CITY OF ALBUQUERQUE

July 19, 2018

**RE: Sawmill Market
1909 Bellamah NW
Grading and Drainage Plan
Engineer's Stamp Date: 7/11/18
Hydrology File: J13D017A**

Based on the submittal received 07/11/2018, the Grading and Drainage Plan **is not** approved for Building Permit or SO-19 Permit. The following comments need to be addressed for approval of the above referenced project:

PROPOSED
DRAINAGE
PLAN

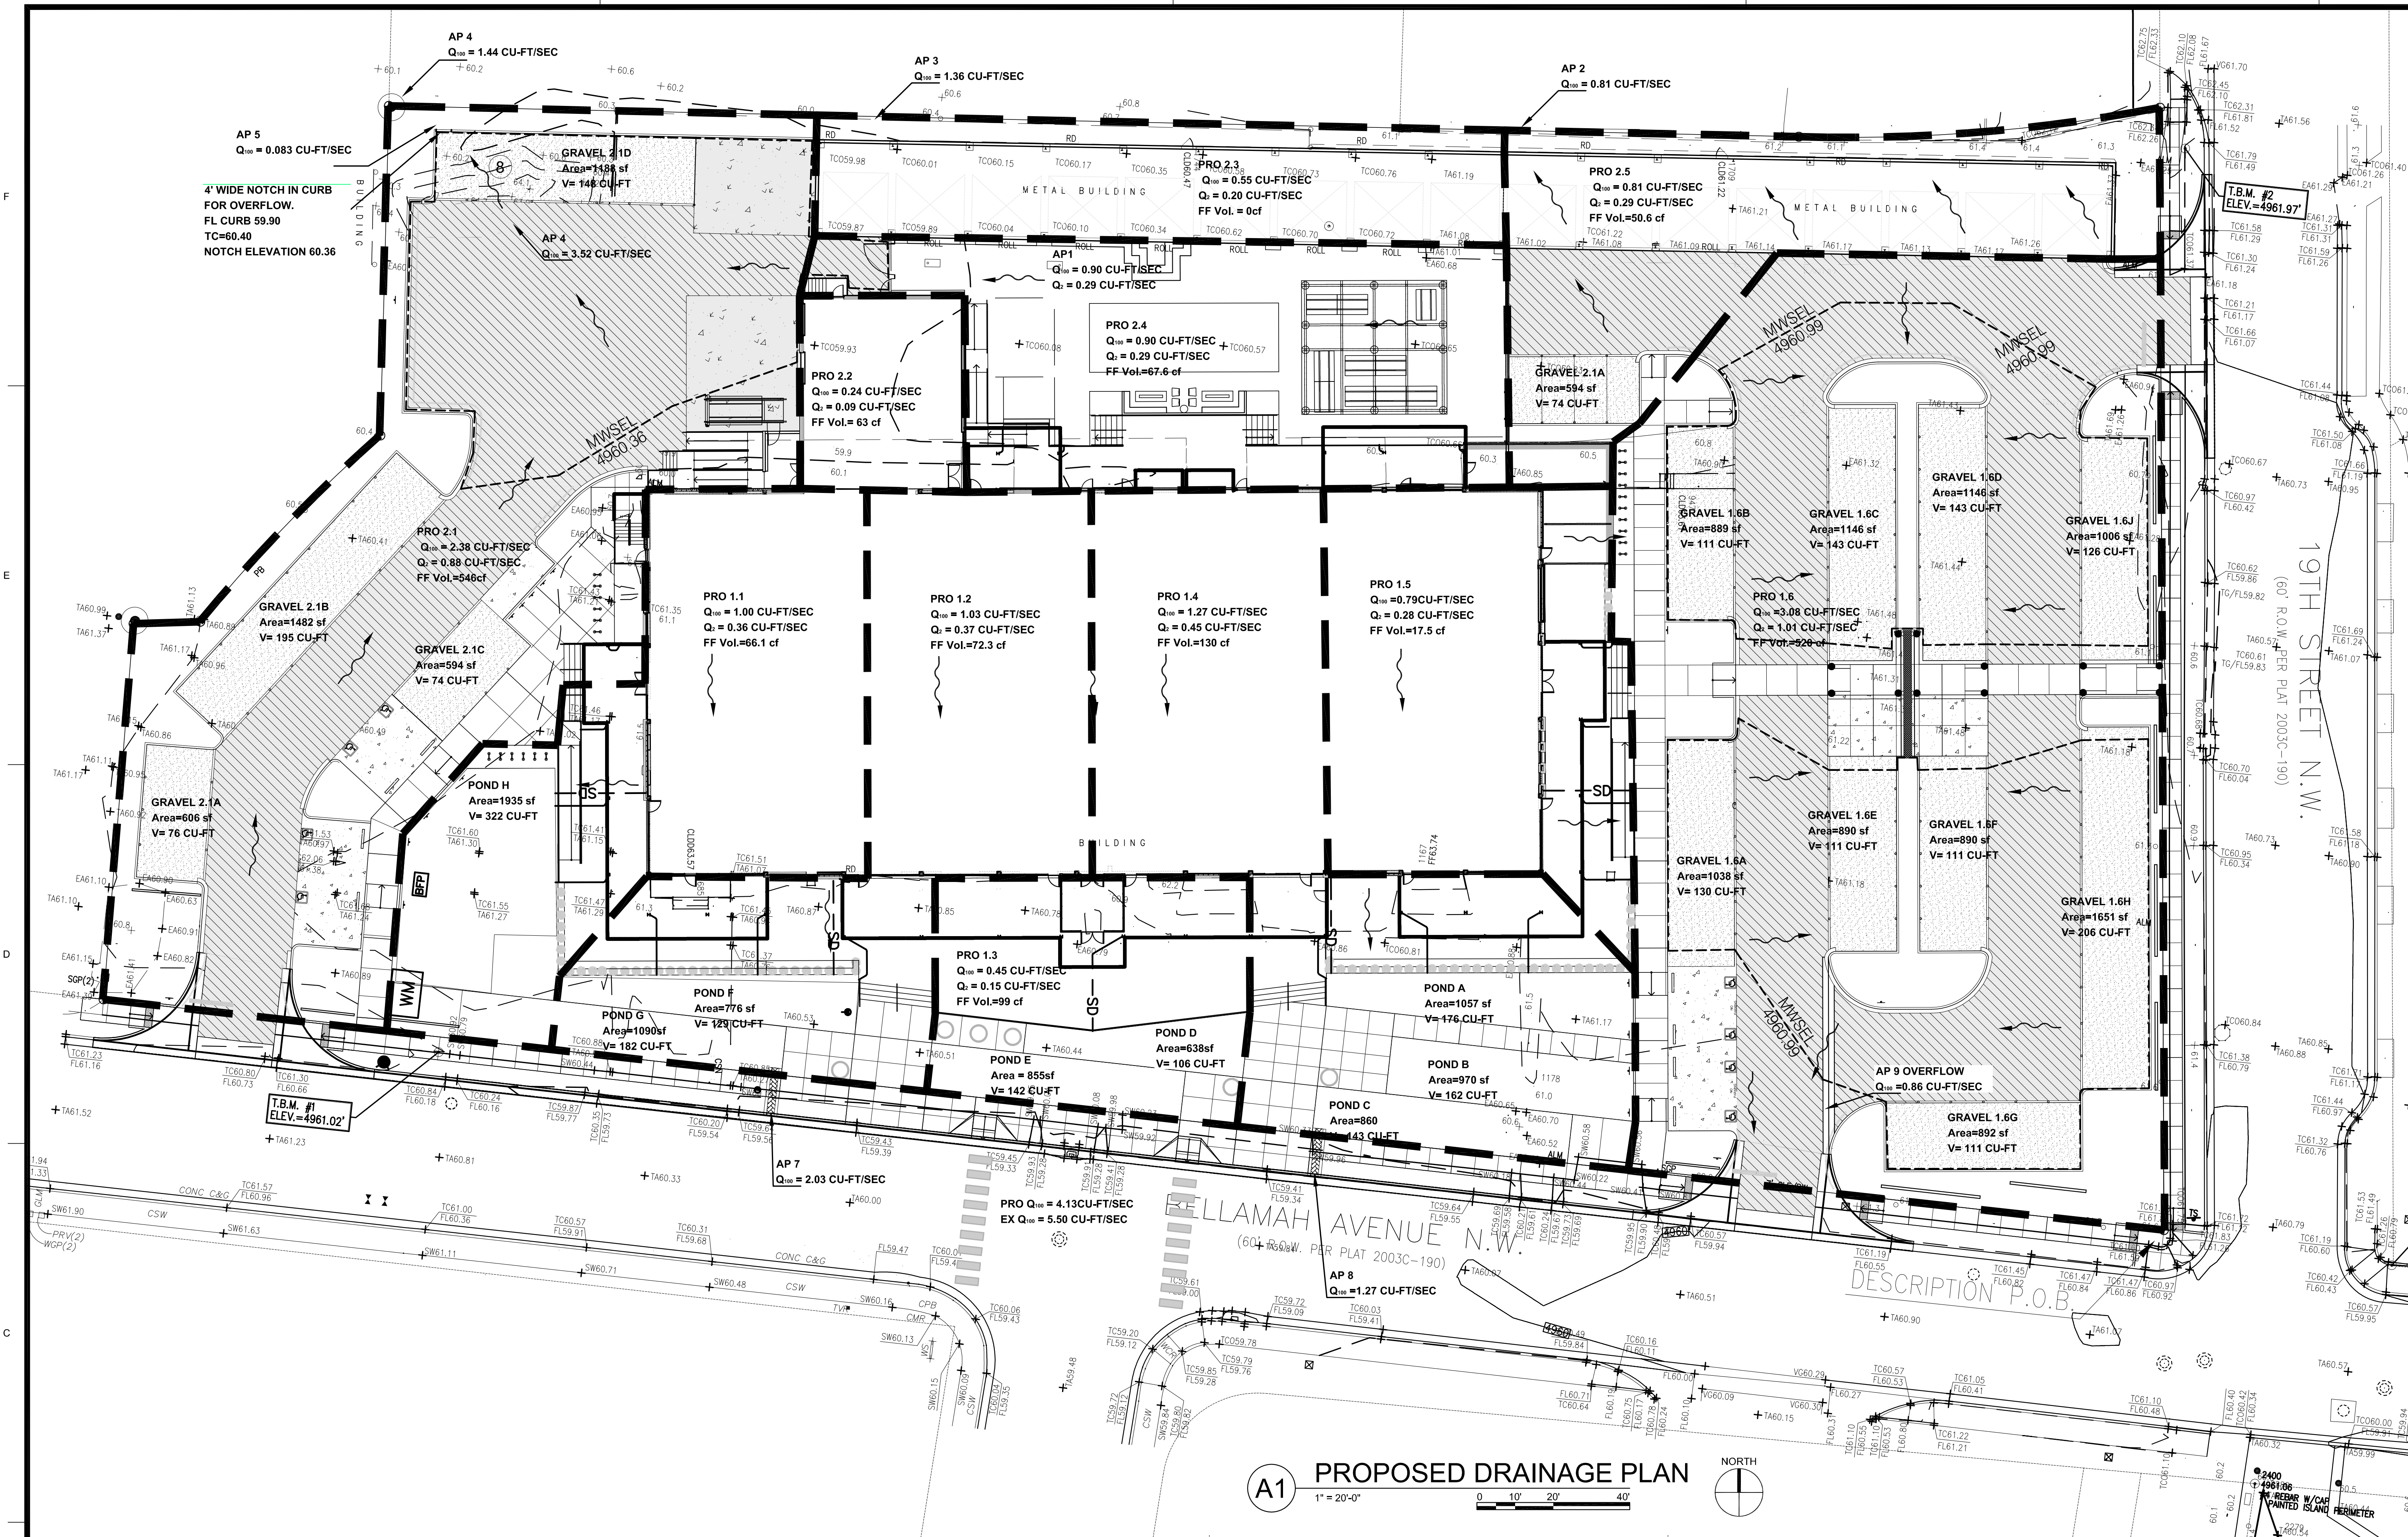
3. Add note on the grading plan that "No work shall be performed in the public ROW without an approved Work Order or Excavation Permit."
4. The ponds described on the drainage plan need to be shown on the grading plan, supported with proposed contours, spot elevations, top of pond elevations, and bottom of pond elevations.

OVERALL SITE GRADING PLAN

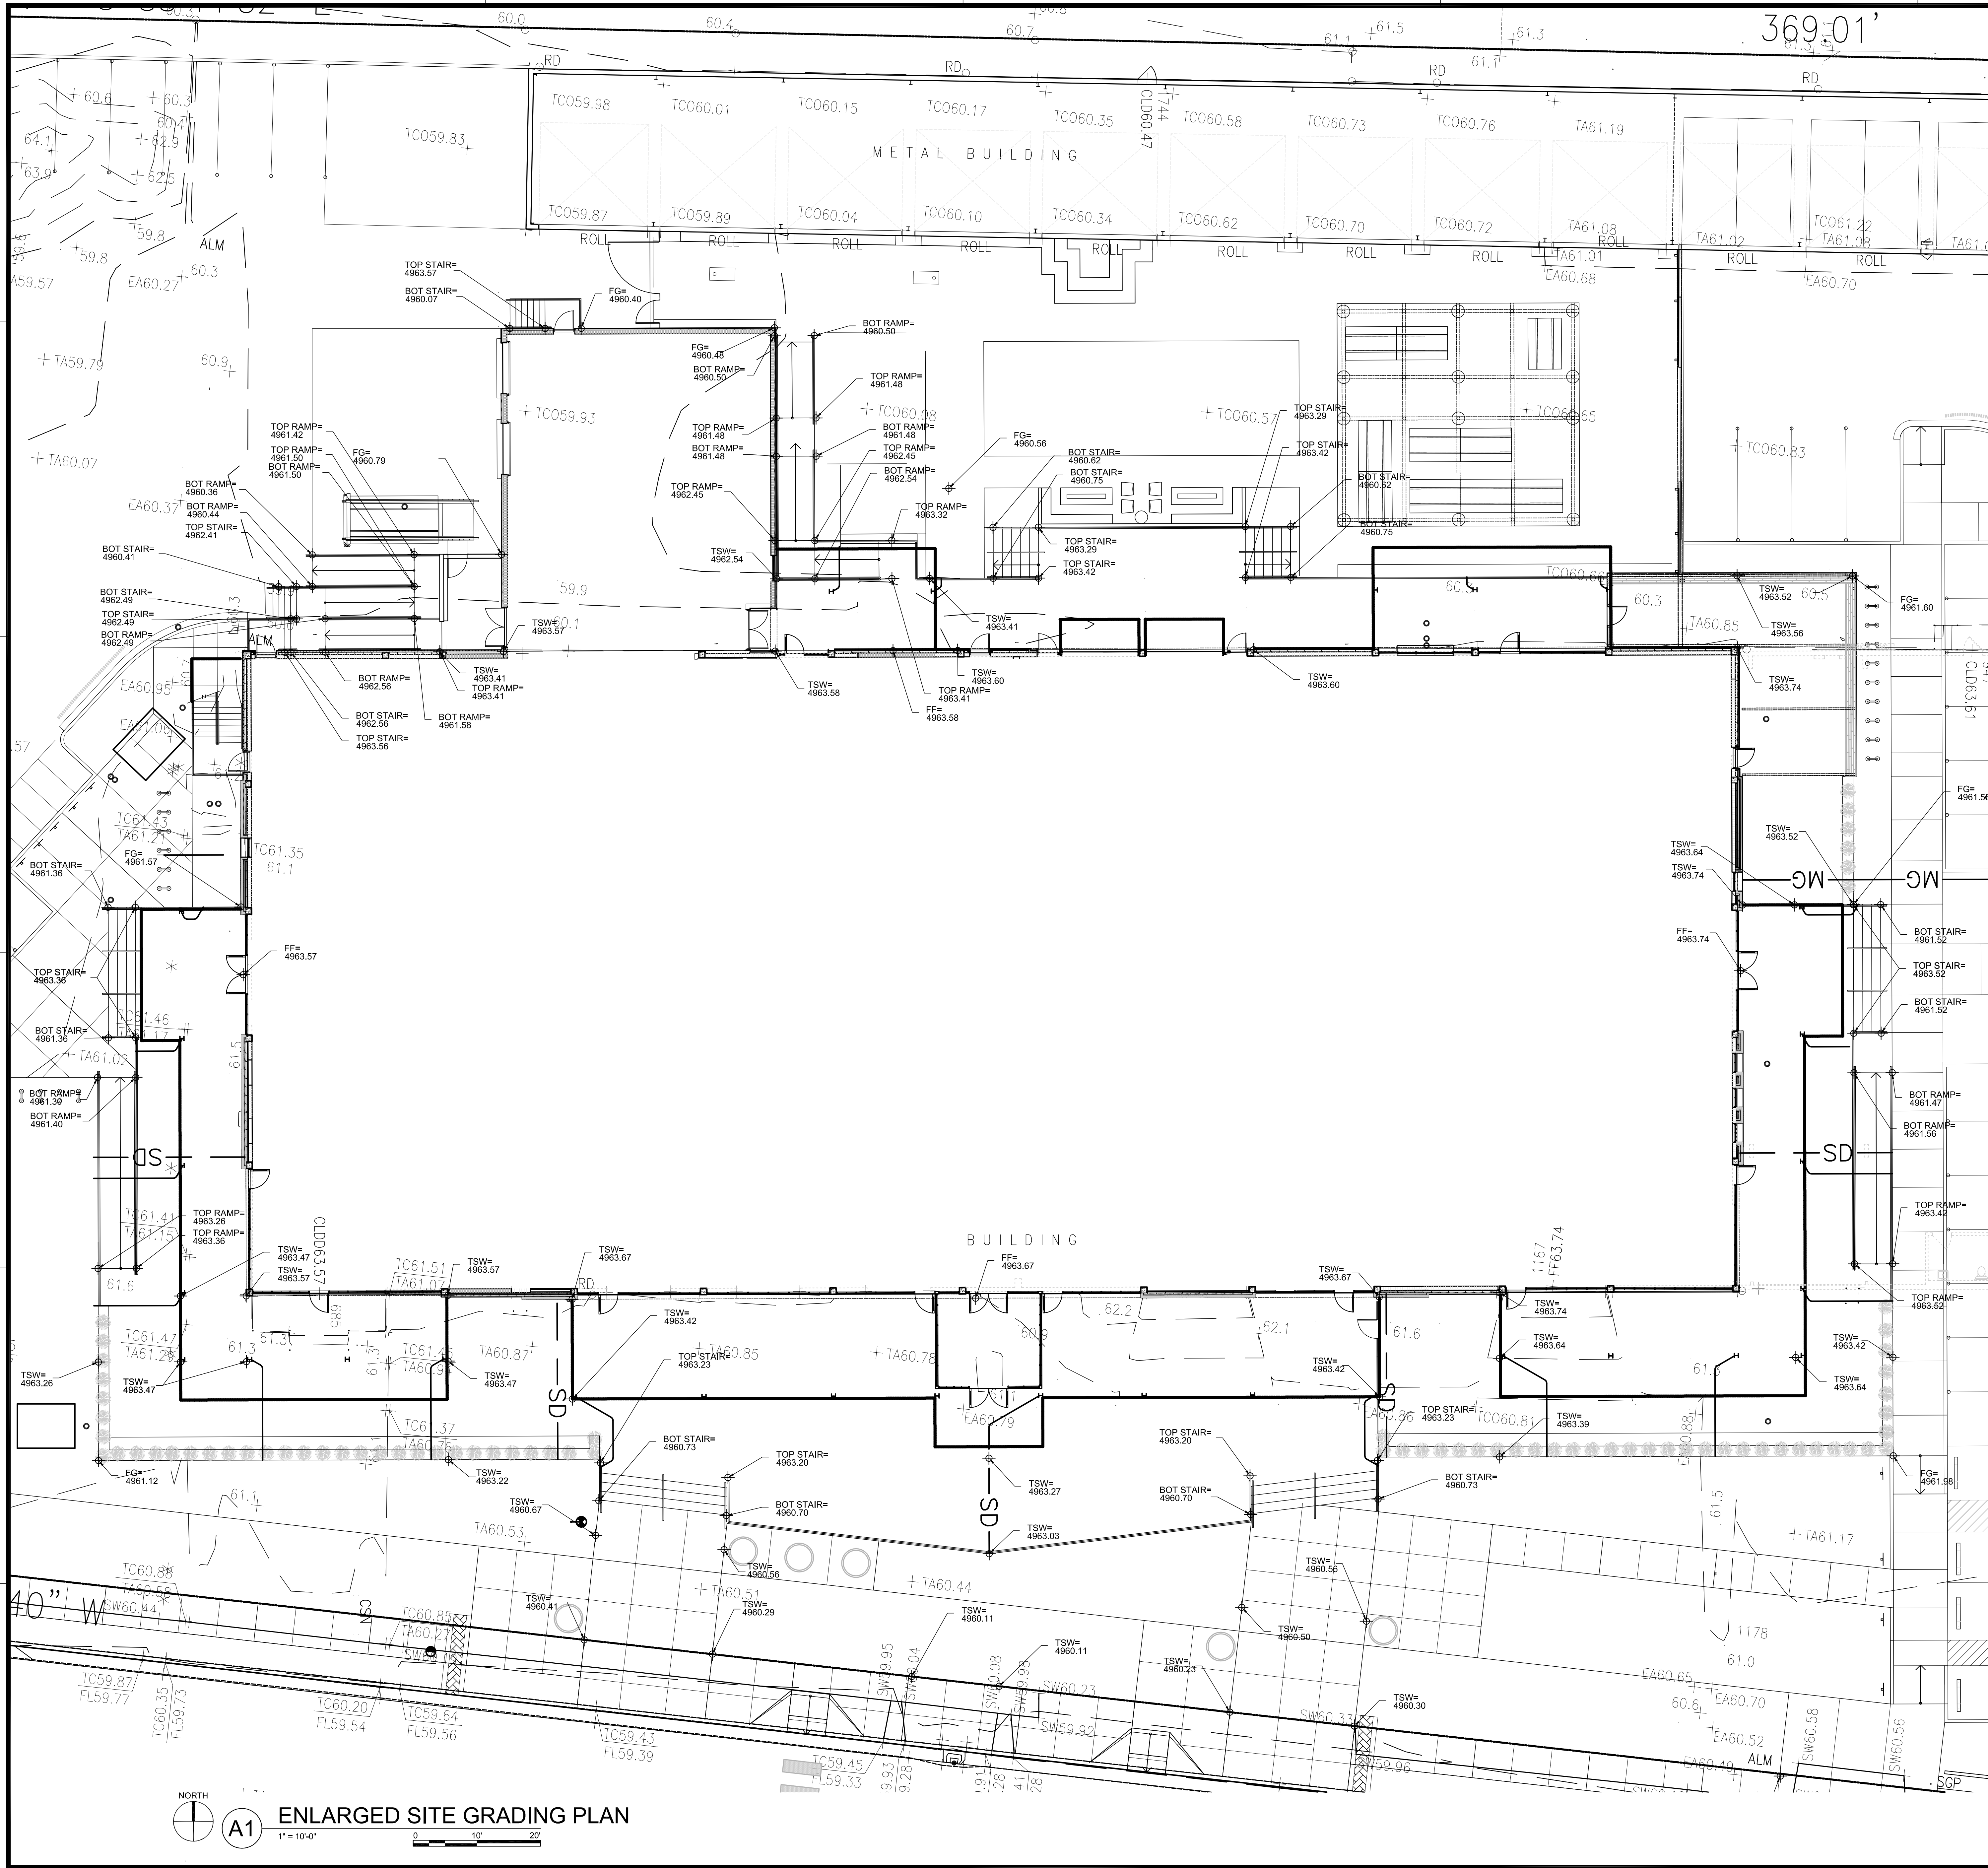
2. The SO-19 work needs to be clearly defined. Please callout the sidewalk culverts and provide dimensions, inverts in, inverts out, and reference Std Dwg 2236 for their construction.

5. Build notes for the areas of new paving, paving to remain, gravel-pave, and concrete work also need to be provided on the grading plan. Alternatively, if a separate paving plan was prepared to describe this work, please provide it.
